### **Rezoning Transportation Analysis**

Petition Number: 2017-203

From:	Kelsie Anderson, PE Kelsie.Anderson@charlottenc.gov 704-432-5492	Reviewer:	Carlos Alzate calzate@charlottenc.gov 704-432-0672	
	Revision Log:	Date		Description
		01-12-2018		First Review
		02-16-2018		Second Review

Figure 7: South Tryon Segment 1 Proposed Section (Near term)

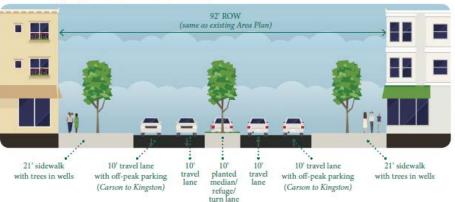
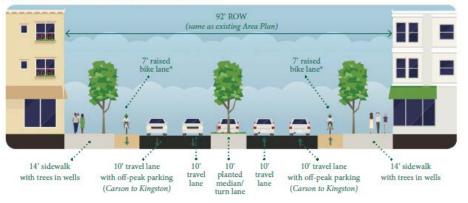
4. The recent South Tryon Corridor Study proposed a future cross-section that includes 7 foot raised bike lane. The petitioner should revise the site plan to show the future curbline as noted in Comment 1a for zoning purposes but construct the interim curbline at 25' from centerline and remove the future recessed parking on South Tryon St.

Below are the future cross-sections of South Tryon St:
